ENGINEERING CLARIFICATION

EC TITLE: Facility 100 Joists
PROJECT: 3 Kings Water Treatment Plant

EC NO.: 65
DATE: 9/1/2020
STATUS: Acknowledged

1 JOIST J100-1
3/8"=1'-0"

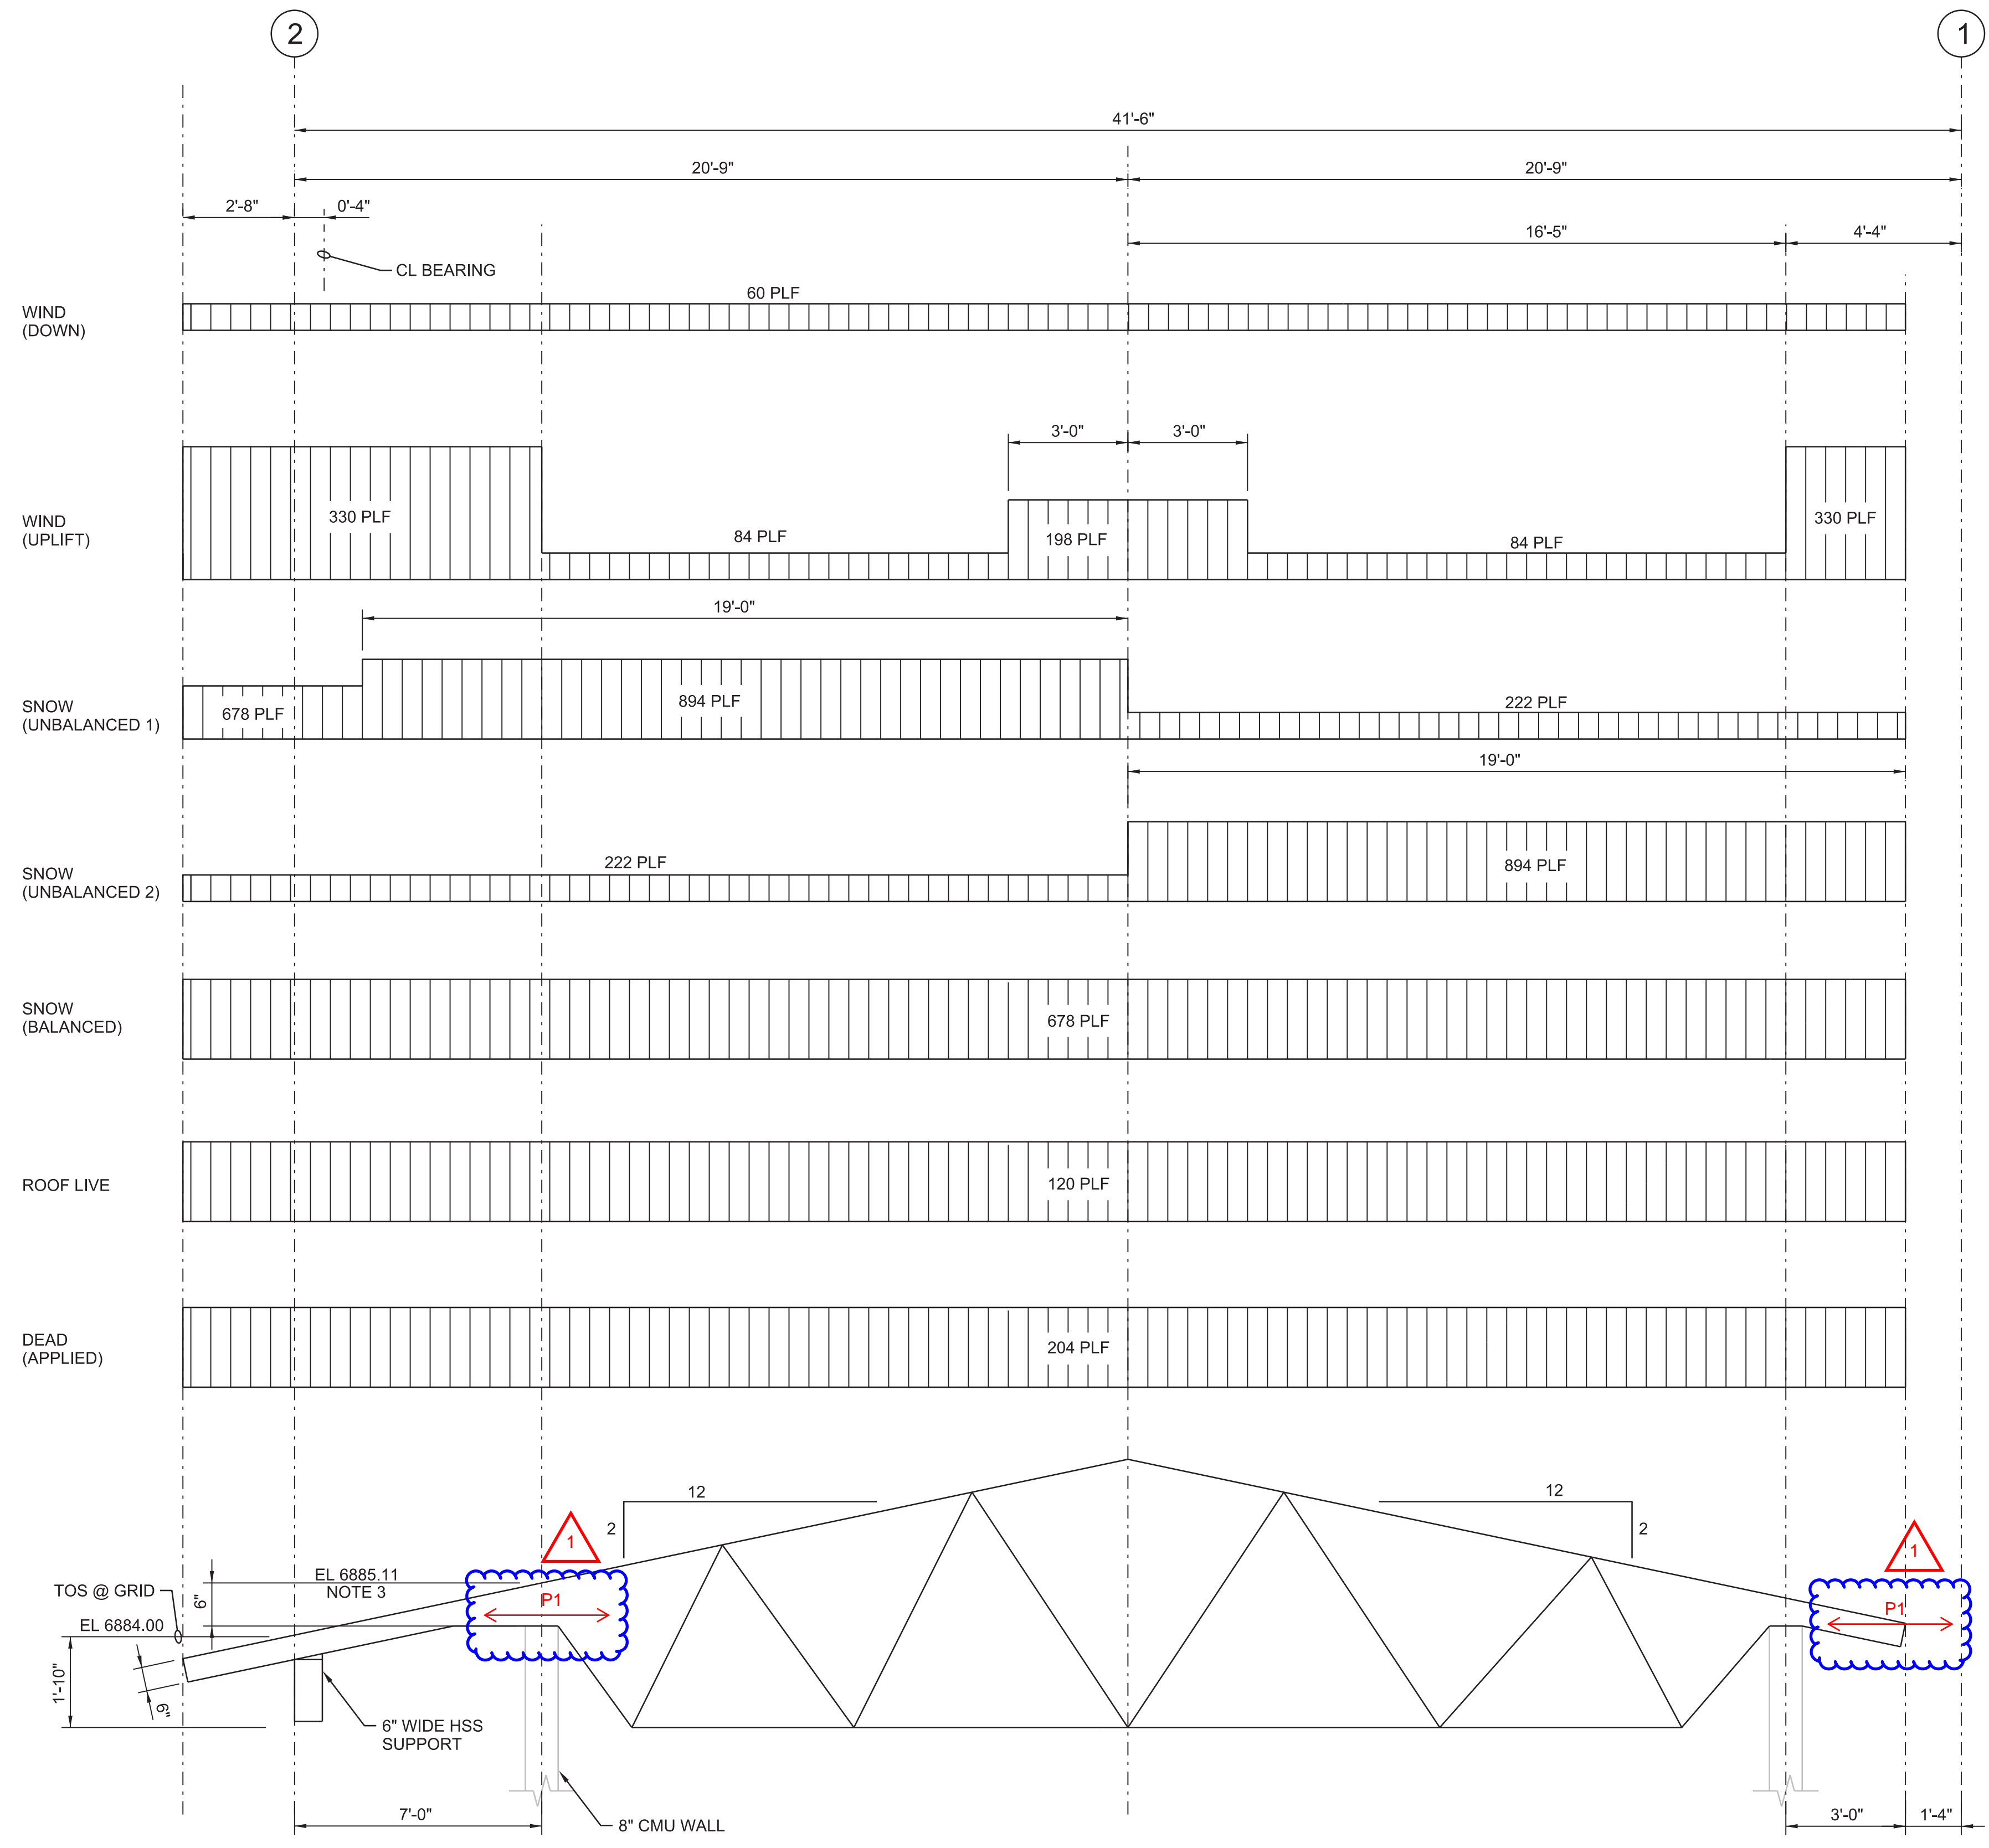
Wind and seismic loads for joists were not included in the loading diagrams on the Drawings.

DRAWING NO.: 100-S-5013 STRUCTURAL - FACILITY 100 - **POTENTIAL COST IMPACT:**
JOIST PROFILES - JOIST J100-1

See attached drawings for wind and seismic loading of joists.

POINT LOAD TABLE	
LOAD	P1
WIND	1.2 KIP
SEISMIC	1.4 KIP

POINT LOAD IS APPLIED AT WALL TO JOIST CONNECTION AND SHOULD BE APPLIED IN BOTH DIRECTIONS
